Well Name: BREECH C	Well Location: T26N / R6W / SEC 12 / SESE / 36.4968 / -107.41327	County or Parish/State: RIO ARRIBA / NM
Well Number: 689M	Type of Well: CONVENTIONAL GAS WELL	Allottee or Tribe Name:
Lease Number: NMNM03554	Unit or CA Name:	Unit or CA Number:
US Well Number: 300392266900S1	Operator: CROSS TIMBERS ENERGY LLC

Type of Submission: Notice of Intent Type of Action: Plug and Abandonment

CONDITIONS OF APPROVAL

Notice of Intent – Plug and Abandonment

Cross Timbers Energy

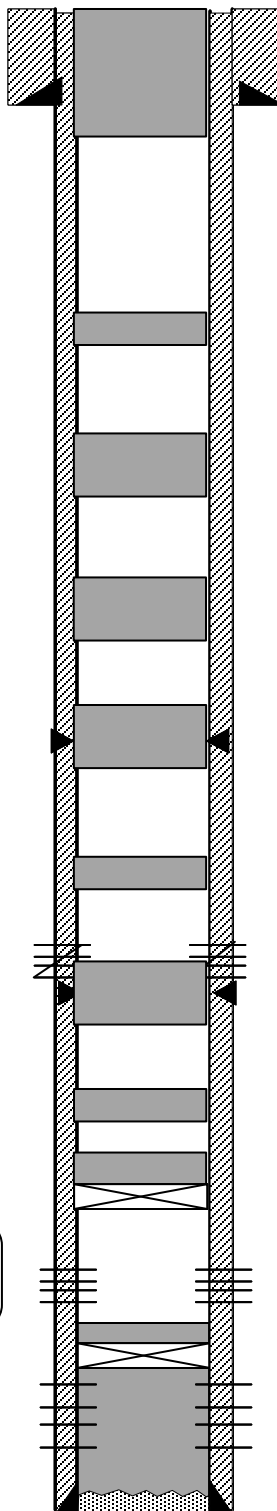
- a. Modify Plug 2: Move TOC to 6246' and BOC to 6396' to cover the BLM geologist's pick for the Gallup at 6346'.
 - b. Modify Plug 3: Move the TOC to 5391' to cover the BLM geologist's pick for the Mancos at 5491'.

- c. Modify Plug 4: Move TOC to 4661' and BOC to 4811' to cover the BLM geologist's pick for the Cliff House at 4761'.
 - d. Modify Plug 5: Move TOC to 3521' and BOC to 4041" to cover the BLM geologist's pick for the Chacra at 3991'.

- e. Modify Plug 6: Move TOC to 2741' and BOC to 3131' to cover the BLM geologist's pick for the Pictured Cliffs at 3081' and Fruitland at 2841'.
 - f. Modify Plug 7: Move TOC to 2421' and BOC to 2671' to cover the BLM geologist's pick for the Ojo Alamo at 2521' and Kirtland at 2621'.

- g. Modify Plug 8: Move TOC to 1531' and BOC to 1681' to cover the BLM geologist's pick for the Nacimiento at 1631'.
3. **Notification:** Farmington Office is to be notified at least 24 hours before the plugging operations commence at (505) 564 7750.

Created By	Condition	Condition Date
mkuehling	NMOCD agrees with BLM on formation tops except Dakota = 7318 Mancos= 5480 - adjust plugs accordingly - Tubing tag required for Graneros plug - plug 5 should have 100 feet above dv tool -- All plugs determined by CBL - Notify NMOCD 24 hours prior to moving on - monitor string pressures daily report on subsequent - submit all logs prior to subsequent	3/19/2025

Plug 9 (Surf Shoe) – Spot Plug 40
sx cmt 341' to surface

Plug 8 (Nacimiento) – Balance Plug
18 sx cmt (1681-1531')

Plug 7 (Kirtland/Ojo) – Balance
Plug 30 sx cm (2671-2421')

Plug 6 (PC/FC) – Balance Plug 46 sx cmt
(3131-2741')

Plug 5 (Chacra and DV Tool) – Balance Plug 61
sx cmt (4041-3521')

Plug 4 (Mesa Verde) – Balance plug 18 sx
cmt (4811-4661')

Plug 3 (Mancos and DV Tool) – Balance
plug 29 sx cmt (5637-5391')

Plug 2 (Gallup) – Balance plug 18 sx cmt
(6396-6246')

Plug 1 (Tocito Perf) – CIBP Set @ ~6781'
with 18 sx cmt on top (TOC ~6,631')
